JOINT REGIONAL PLANNING PANEL (Southern Region)

SUPPLEMENTARY REPORT

JRPP No	2017STH008
DA Number	97/2017
Local Government Area	Shellharbour
Proposed Development	18 dwellings and 18 lot Torrens title subdivision
Location	Lot 2043 in DP 1203745, The Promontory Drive, Shell Cove Lot 2116 in DP 1203746, Wharf Parade, Shell Cove
Date of report	5 July 2017
Report prepared by	Victoria Nicholson, Senior Development Assessment Officer
Report endorsed by	Melissa Boxall, Acting Director Community and Customers Jasmina Micevski, Acting Team Leader City Development (Planning)

Attachment 1 – Photos of a completed terrace style dwelling

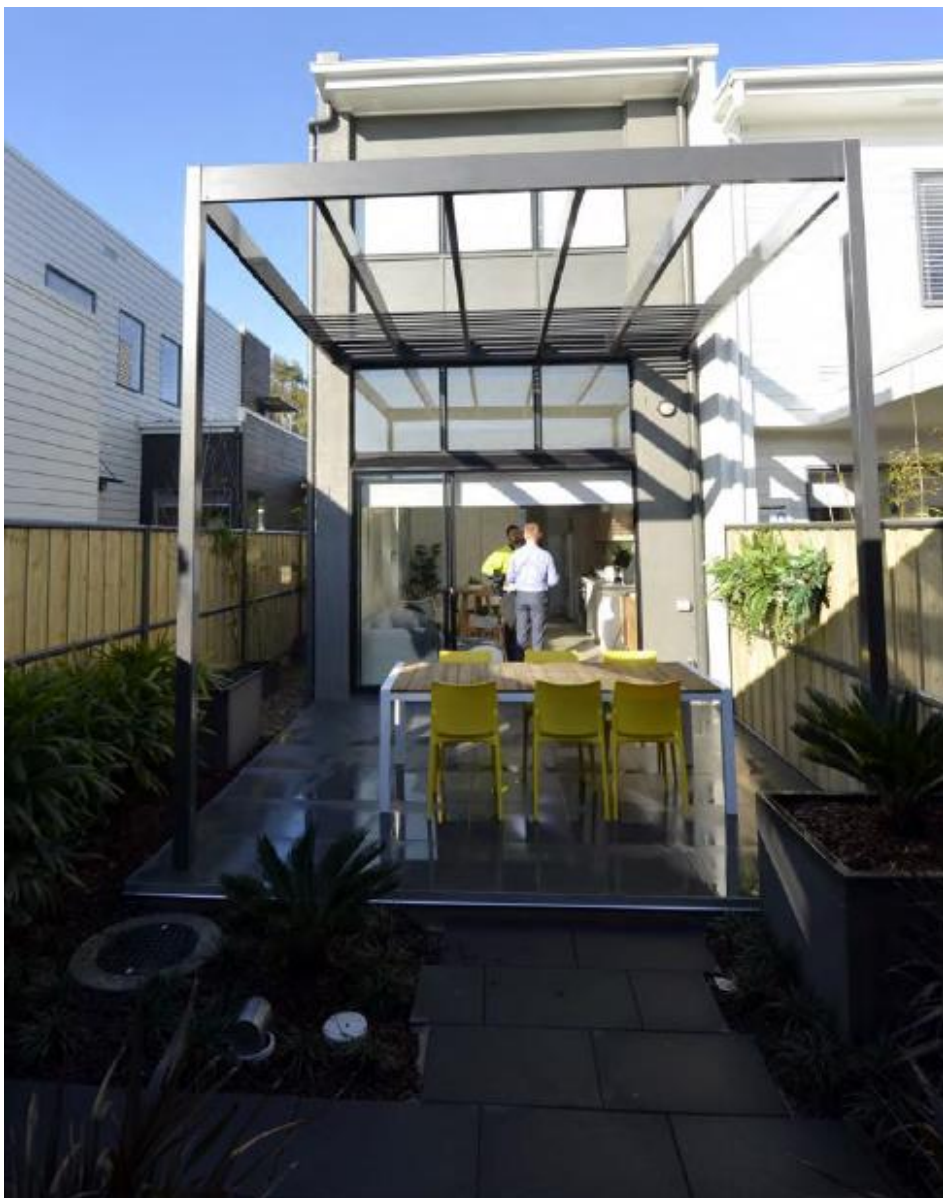
- Lots 9402 and 9407 are provided with the AR4 Terrace, which is a 2 storey 2 bedroom terrace house with detached carport. We have successfully sold and constructed a number of these terraces in our medium density development at Fairwater in Blacktown
- The houses are both provided with a 1.2m side setback for the location of services and equipment, leaving the rear Alfresco area free for outdoor living areas and associated landscaping.
- The ground floor living areas to these terrace houses are provided with 3m high ceilings and floor to ceiling glazing to the rear elevation, thus admitting the maximum possible natural light to these spaces.
- Photos of a completed equivalent 'AR4' terrace house in our Display Village at Fairwater are attached in Appendix 1 for reference. The photos demonstrate the quality and amenity that is provided to the living area of these homes.

Attachment 1 (page 11) includes 2 photos of an equivalent 'terrace style' dwelling referred to in the above comment from the applicant.

The high floor to ceiling heights, full length glazing to allow light penetration and solar access, interior designed floor layouts and direct connectivity between internal and external living areas will assist in providing a liveable dwelling with high amenity. Privacy of the dwellings that adjoin the 'terrace' style dwelling is achieved through roofing of the private open space areas of the adjoining dwellings, articulated building footprint, rooms along the common wall being of same

Council can support these dwellings on small lots as proposed where they contribute to the variety in housing mix both in terms of built form and diversity. These terrace inspired dwellings will account for 11% of the 18 dwellings being proposed, a proportionate mix of dwelling type that should not detract from the streetscape and character of the area, while still being mindful of the residential density targets of the Shell Cove Boat Harbour Precinct Concept Approval.
